## Maserati Technical Bulletin

Date: 2/03/2016  
Bulletin No: MTB-200917G  
Supersedes: MTB-200917F  
Section: Engine

**Model Type:** Quattroporte Automatic (M139) & GranTurismo (M145)  
**Model Year:** 2007 to 2009  
**Subject:** Addendum - Noise from variator

Figure 1 – Front camshaft bearing cap

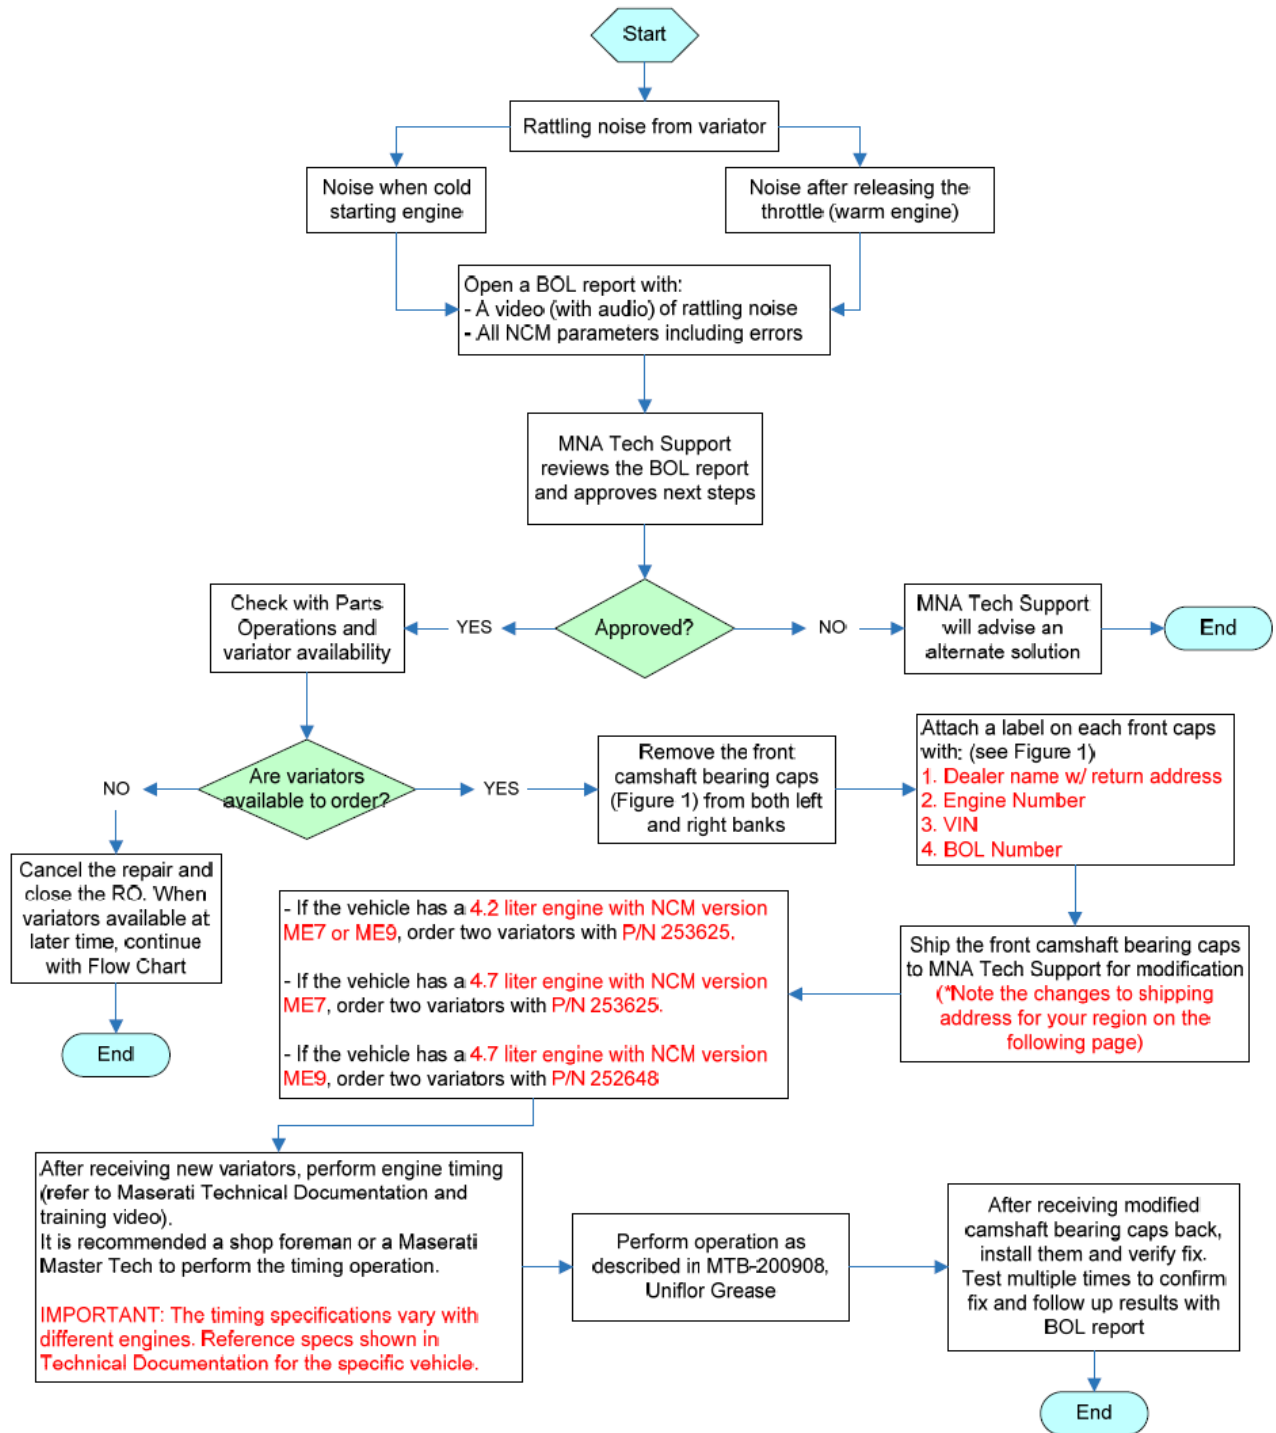
Note: The camshaft bearing caps are not available separately and can only be supplied with a complete head assembly. The front camshaft bearing caps will be modified by MNA and do not need to be replaced.
